## I-45 North Houston Highway Improvement Project

# DESIGN SPECIFIC REQUESTS & RESPONSES BY NHHIP SEGMENT

# SEGMENT 3

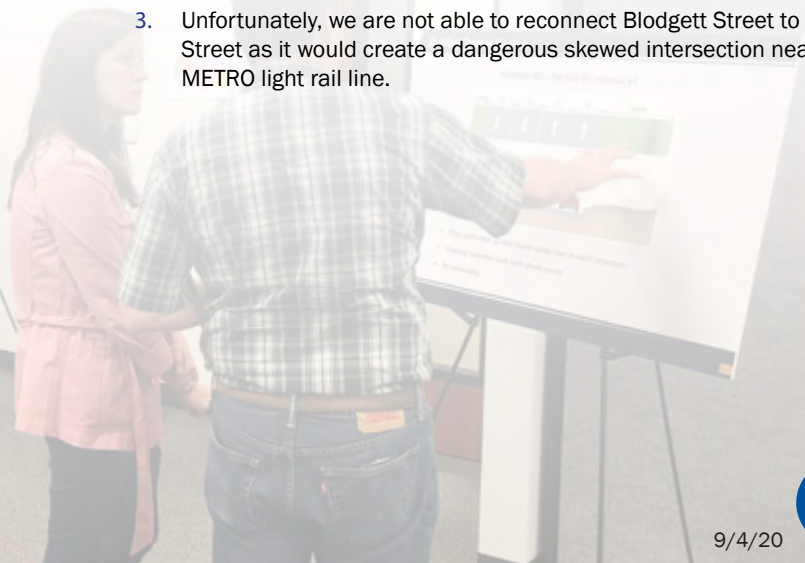
1. Add a Gregg Street eastbound exit ramp from I-10.
2. Close McKinney Street across the freeway (Councilmember Gallegos request).
3. Convert Walker Street into a pedestrian/bicycle only facility over freeway lanes (Councilmember Gallegos request).
4. Connect Cleburne Street across US 59/I-69.
5. Remove Montrose Bridge reconstruction from plan.
6. Remove impact to White Oak Park.

1. Adding this ramp appears to be feasible and will be further explored during the upcoming detailed design phase.
2. TxDOT has no objection to closing McKinney Street over the freeway, but the decision lies with the City of Houston. This can be decided after the ROD and incorporated during the detailed design phase.

3. TxDOT has no objection to converting Walker Street to a pedestrian/bicycle facility over the freeway, but the decision lies with the City of Houston. This can be decided after the ROD and incorporated during the detailed design phase.

4. We have completed a preliminary evaluation and re-establishing this connection appears to be feasible. We will study in more detail during the detailed design phase.

5. Montrose Bridge reconstruction removed from plan.
6. Revised design of the I-45 southbound to I-10 westbound direct connector to avoid the impact to Freed Art & Nature Park (noted in comments received as White Oak Park).

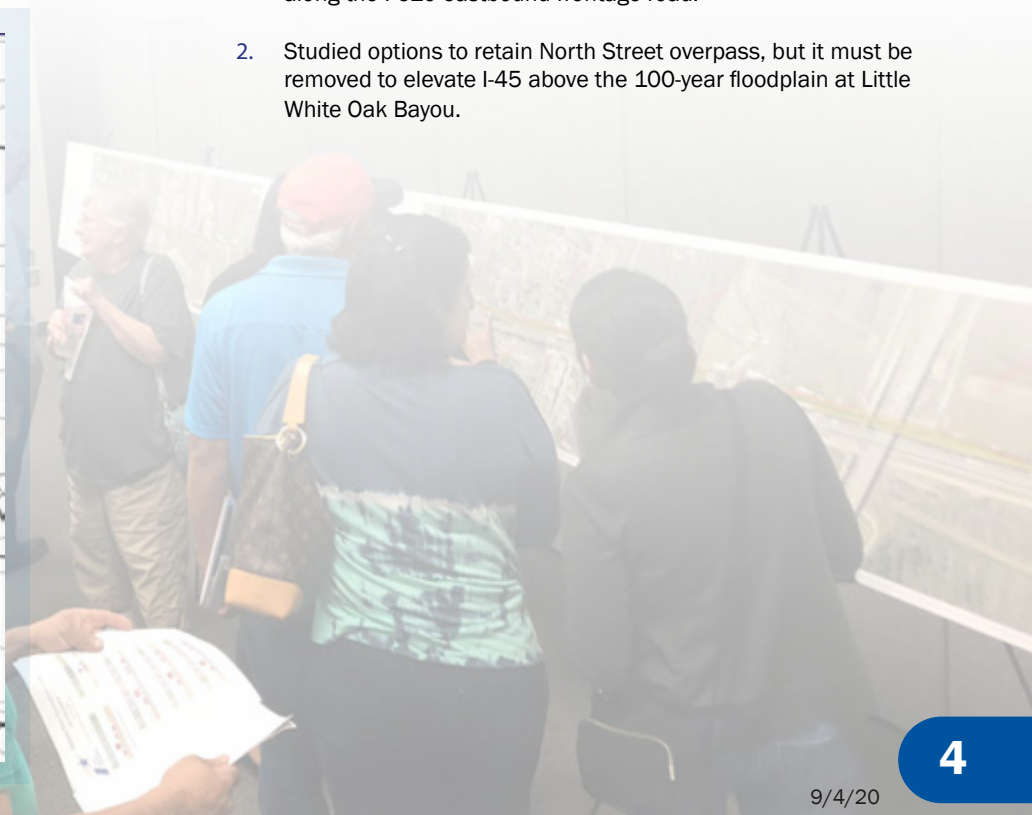
1. Replace Southbound exit ramp to North Main Street that was removed.
2. Provide access from North Street to the new northbound frontage road.

1. Existing southbound exit ramp to North Main Street could not be maintained without additional ROW and closure of Cottage Street to vehicular traffic across I-45. Preliminary design for a southbound exit ramp near Patton Street under review. Adding this ramp will be further explored during the detailed design phase.
2. Revised new I-45 NB frontage road to provide connection to North Street.

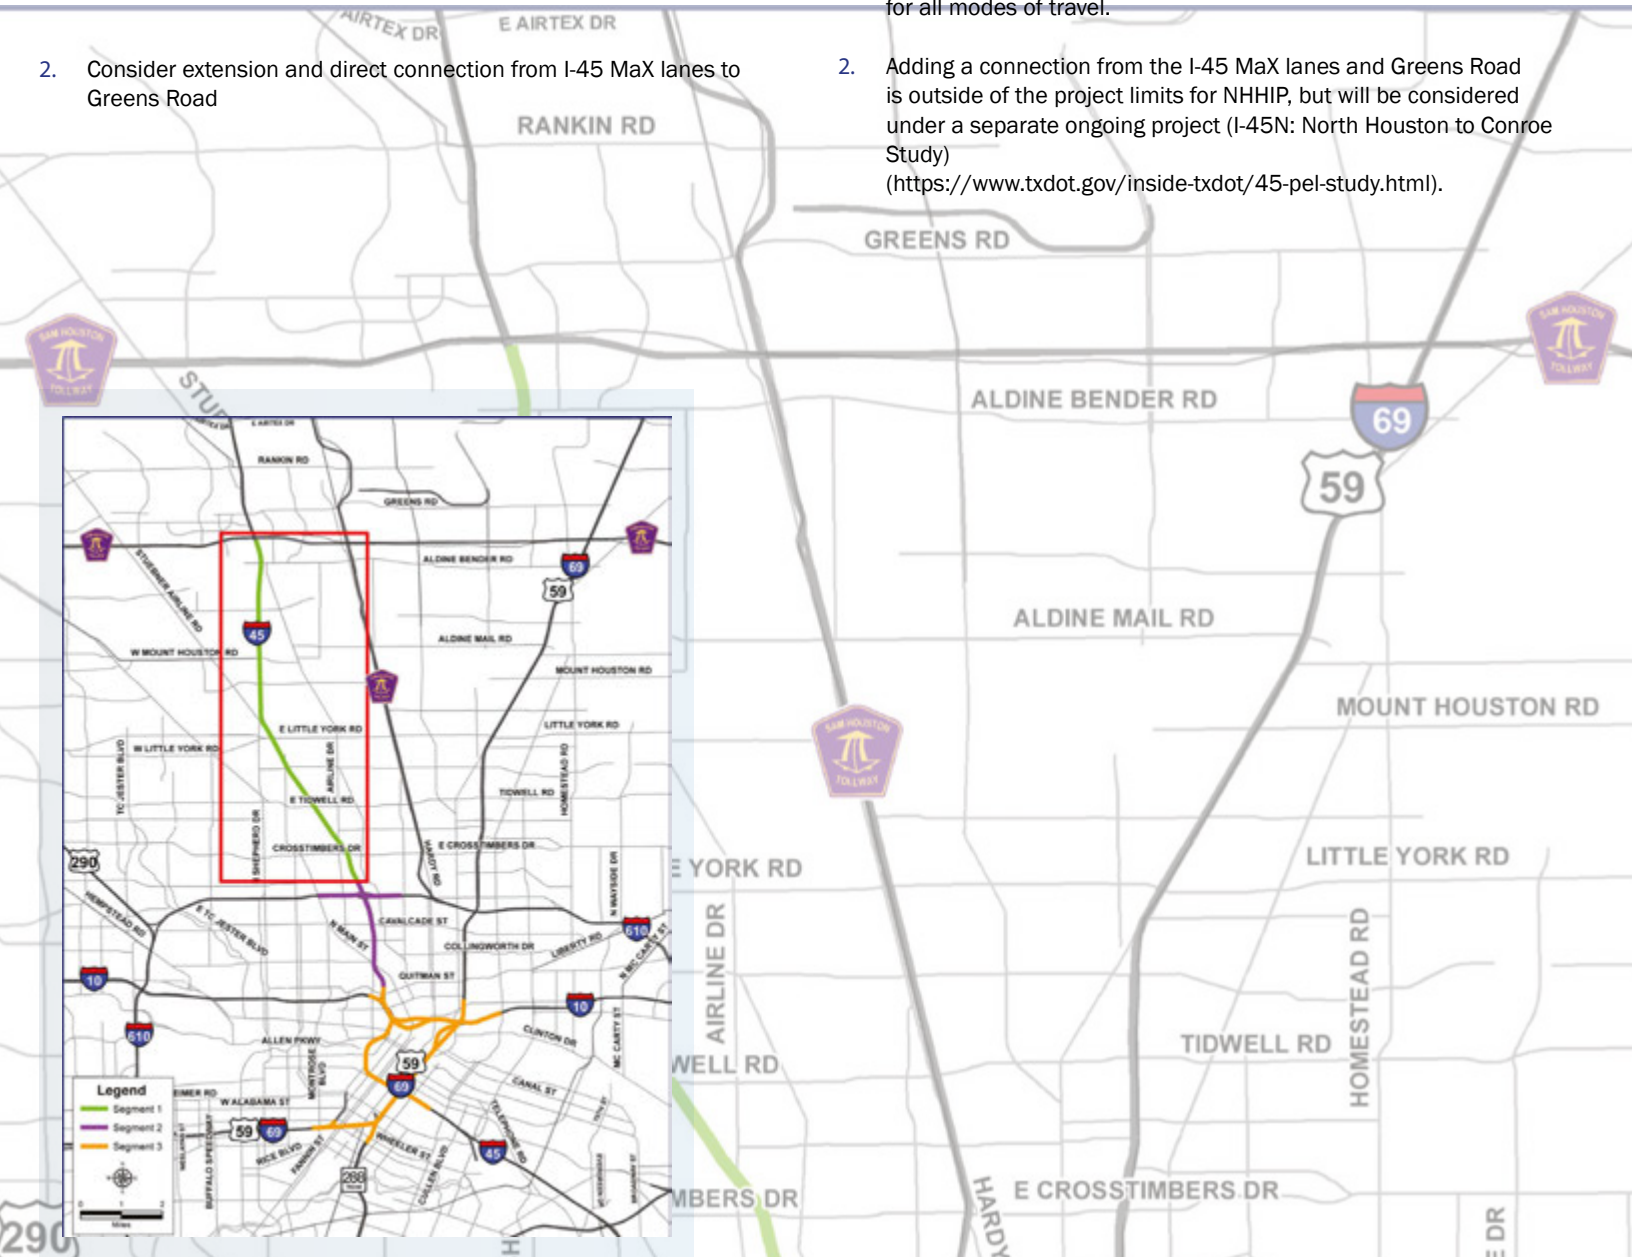
1. All intersections should be designed for safe crossings and accessibility for pedestrians especially with regard to METRO bus stops.
2. All lanes on city streets and frontage roads should comply with City of Houston's 11' lane standards. Multiple streets have been shown with sweeping, large radius turns; project should minimize these issues.
3. Define which intersections are proposed with traffic signals and all-way stop control.

1. TxDOT coordinated with the COH regarding the specific design of the city street network adjacent to and crossing the NHHIP. TxDOT also coordinated with the COH to incorporate the COH Bike Plan and desired bicycle/pedestrian accommodations on city streets. The intersection designs will be further refined during detailed design, in coordination with the COH and METRO.
2. Frontage road design will accommodate large radius turns and intersections will avoid pedestrian islands. The streets parallel to the freeway in Segments 2 and 3 will follow the City of Houston standards and lanes will be 11' wide. The frontage roads in Segment 1 function as a transition between the freeway and the local businesses and need to retain TxDOT design standards of 12' lanes.
3. Frontage road intersection signalization will be determined during the final design phase.
